ADMINISTRATIVE SHORT PLAT REPORT & DECISION

REPORT DATE:	November 5, 2015
Project Name:	Short Plat of Lot A, Cassidy Cove Plat
Owner:	King County, Facilities Management Division, 500 4th Ave Rm 830, Seattle, WA 98104
Applicant:	Anthony Wright, 500 4th Ave Room 830, Seattle, WA 98104
Contact:	Steve Rizika, 500 4th Ave Room 830, Seattle, WA 98104
File Number:	LUA15-000676, SHPL-A, MOD
Project Manager:	Clark H. Close, Senior Planner

Project Location: 3005 NE 4th St, Renton, WA 98056 (APN 143400-0010)

SHORT PLAT
OF LOT A CASSIDY COVE PLAT

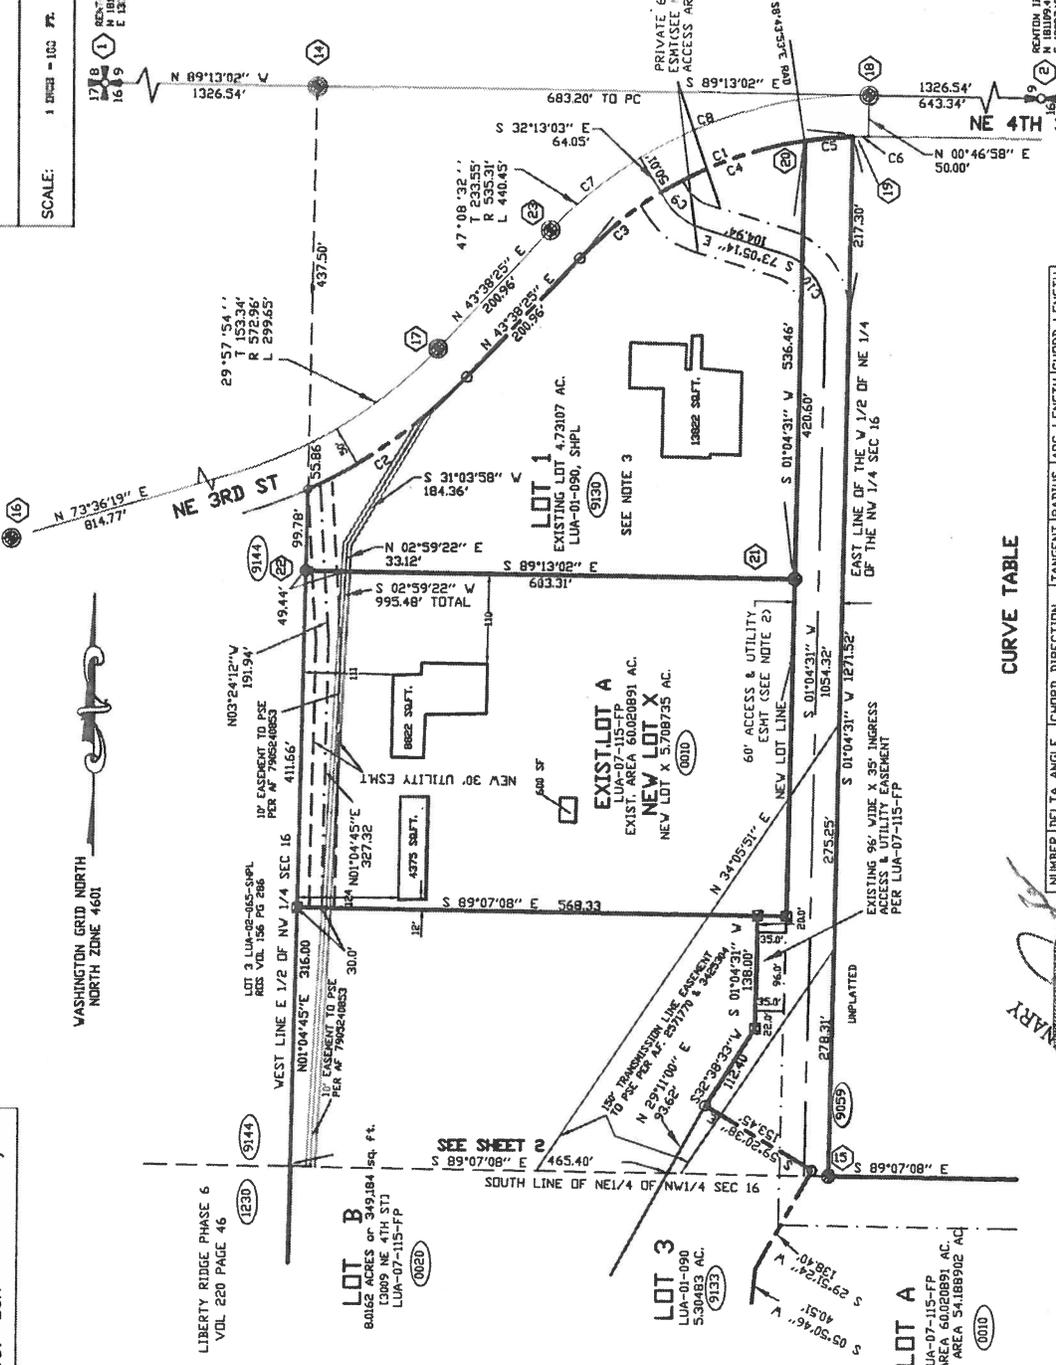
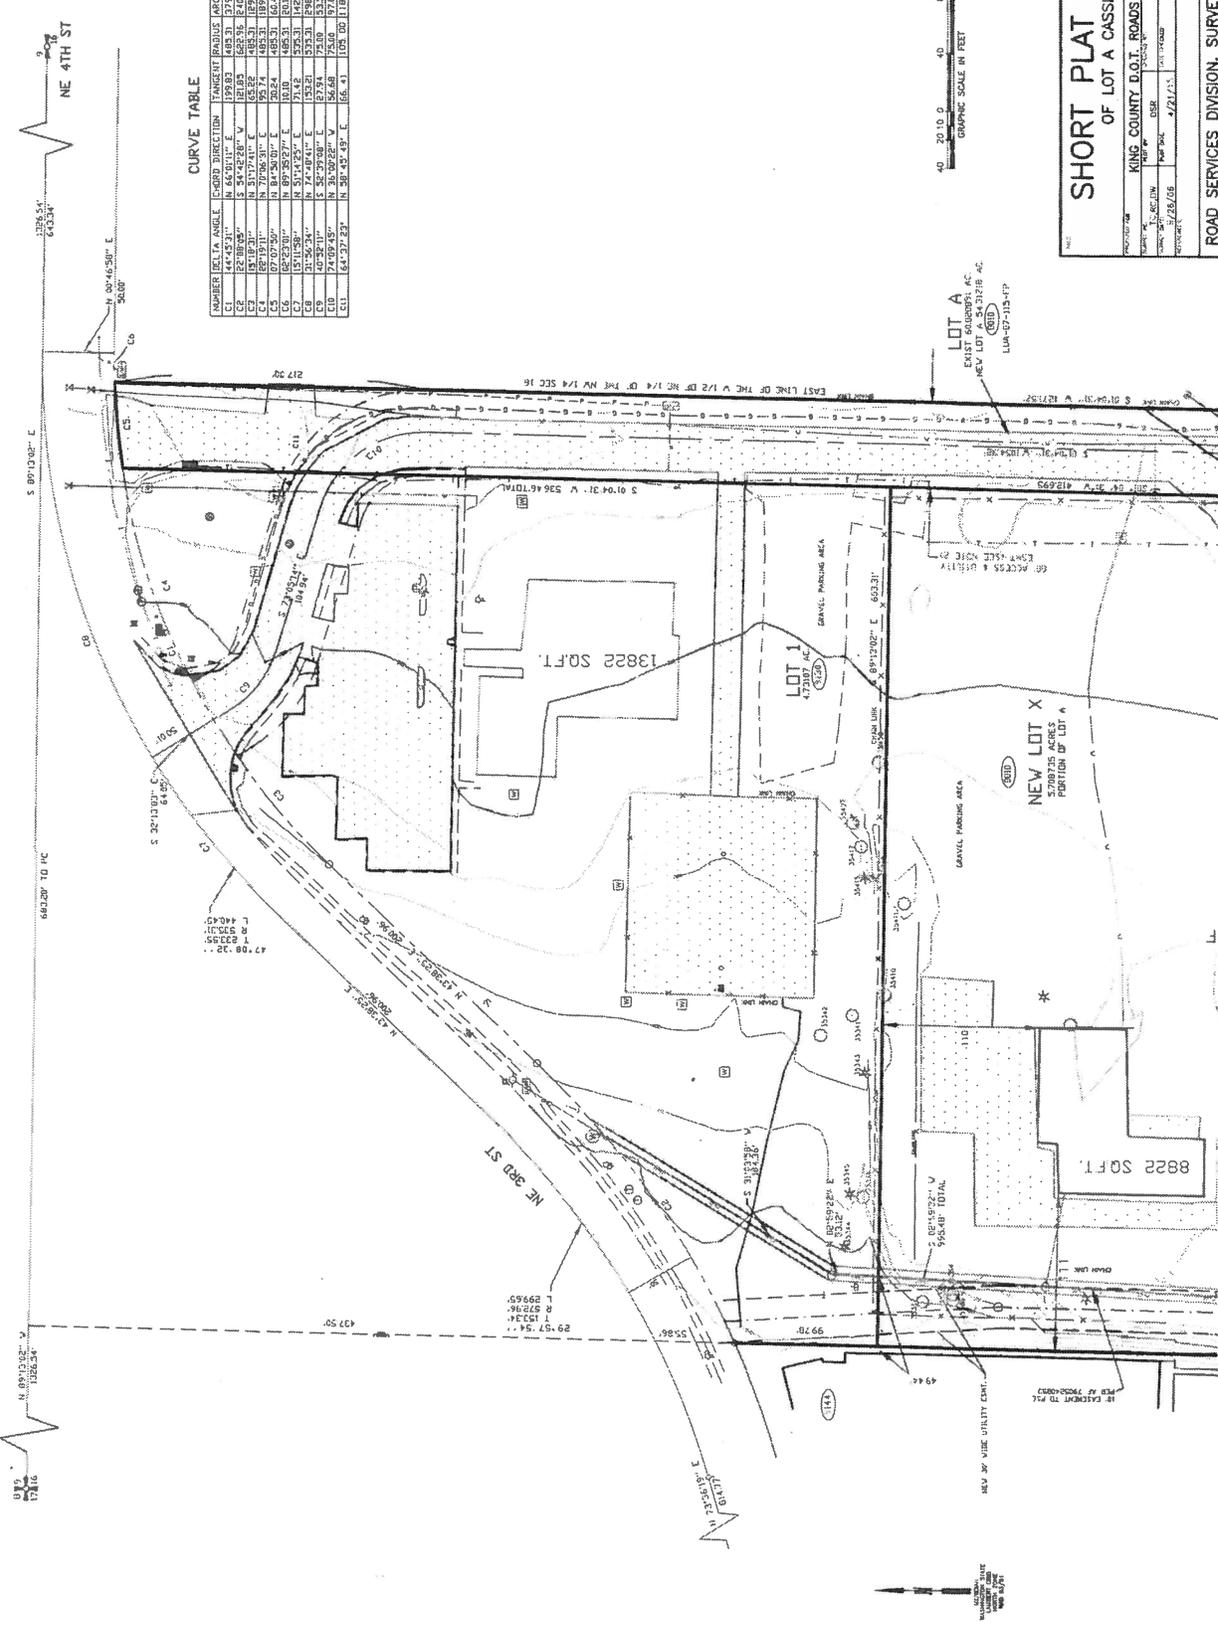
The Plat Map shall include the 30 ft. wide utility easement recorded in 2008 and 2002.

Update the Sheet 1 Section Breakdown and also all Sheet Indexes to reflect only Lot A as the subject parcel.

Update the Short Plat to reflect Lot A as subject parcel by dark lines and shading back the other lines to clearly define the Short Plat Boundaries. This is displayed clearly on the Plat Site Map provided and not as clearly on the Preliminary Short Plat.

Note the City of Renton land use action number and land record number, LUA15 000676 and LND 20 0623, respectively, on the final short plat submittal. The type size used for the land record number should be smaller than that used for the land use action number.

Provide short plat and lot closure calculations.

Indicate what has been, or is to be, set at the corners of the proposed lots. The preliminary map provided indicates the same corner monumentation as shown on the previous plat recorded under Recording No. 20080221001385.

Do include a "LEGEND" block for the short plat drawing, detailing any symbols used thereon. The current "LEGEND" does not include line types.
